UNITED STATES PATENT AND TRADEMARK OFFICE

APPLICATION NO.	FILING DATE	FIRST NAMED INVENTOR	ATTORNEY DOCKET NO.	CONFIRMATION NO.
10/621,064	07/16/2003	Kiyoshi Hirota	MAT-8446US	8839
23122	7590	11/22/2004	EXAMINER	
RATNERPRESTIA P O BOX 980 VALLEY FORGE, PA 19482-0980			THOMAS, ERIC W	
			ART UNIT	PAPER NUMBER
			2831

Office Action Summary

DETAILED ACTION

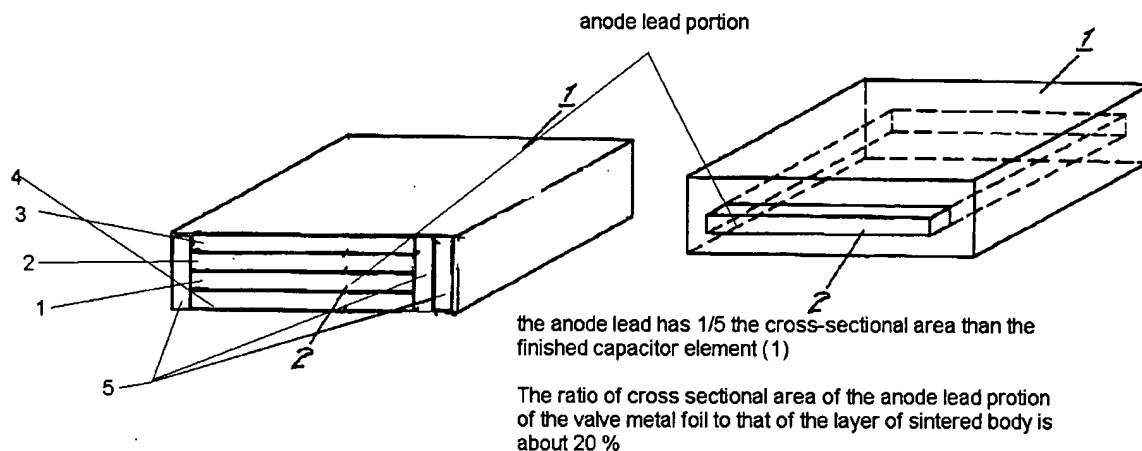
Regarding claim 3, Masuda et al. disclose in fig. 1-2, an anode body for a solid electrolytic capacitor comprising a valve metal foil which makes an anode (2 – see fig. above -- col. 2 lines 20-25), and a layer of sintered body (3) formed of the valve metal provided on the upper and lower surfaces of the valve metal foil, an anode lead extending from the anode on one of the sides, the anode extending to all other of the sides and covered with an insulating layer (col. 3 lines 25-30) on the all other sides (see fig. above).

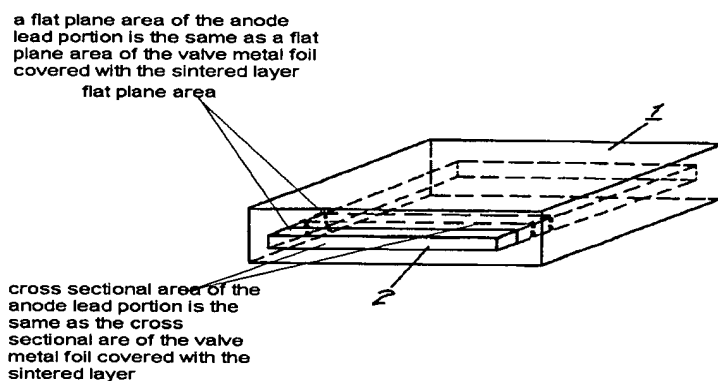
Regarding claim 5, Masuda et al. disclose an anode body for a solid electrolytic capacitor comprising a valve metal foil which makes an anode, and a layer of sintered body formed of the valve metal covering the valve metal foil with exception of an anode lead portion, wherein a ratio of cross sectional area of the anode lead portion of the valve metal foil to that of the layer of sintered body is about 20 % (see illustration above).

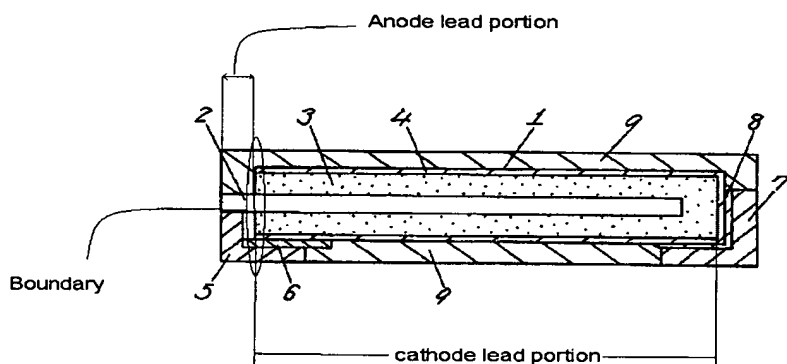
Regarding claim 6, Masuda et al. disclose an anode body for a solid electrolytic capacitor comprising a valve metal foil with makes an anode, and an layer of sintered body formed of valve metal covering the valve metal foil with exception of the anode

lead portion, wherein a flat plane area, and a cross sectional area of the anode lead portion of the valve metal foil have at least the same square measure as the corresponding areas valve metal foil covered with the sintered layer.

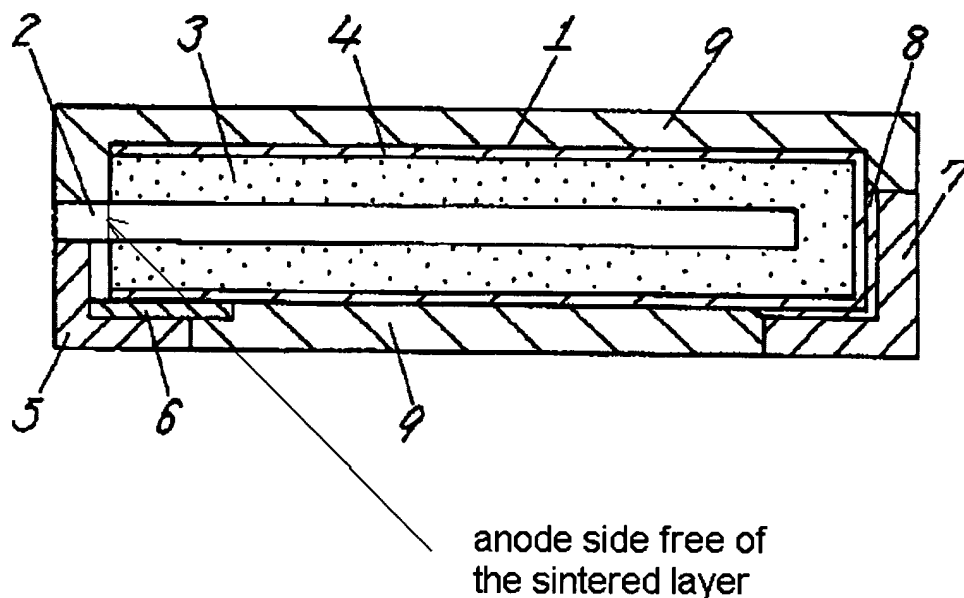
Regarding claim 10, Masuda et al. disclose in fig. 1, & 2, the anode body for the solid electrolyte capacitor, which the anode body having a dielectric film (col. 3 lines 26-28), a solid electrolyte layer (col. 3 lines 26-28), and a cathode layer (4) laminated in the order on the outer surface with exception of the anode lead portion, the anode body included in the solid electrolytic capacitor.

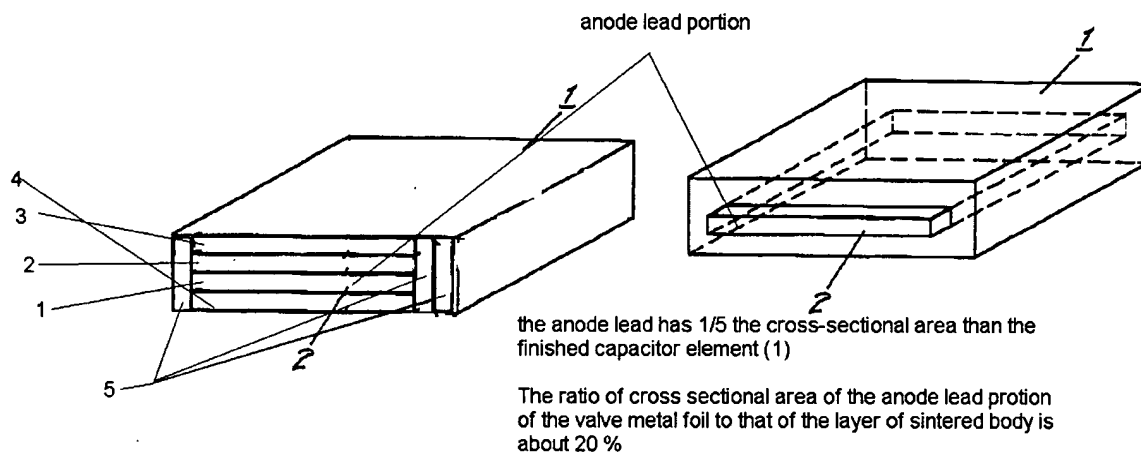
a) The limitation "a flat plane area of the valve metal foil covered with said sintered layer is not less than one half of the flat plane area" is confusing. Figure 1 illustrates the flat plane area of the valve metal foil covered with the sintered layer is the same as the flat plane area (of the valve metal foil covered with the sintered layer).

b) As noted in the claim objections, applicant is requested to delete this limitation from the claim because it does not offer any additional structural limitation.
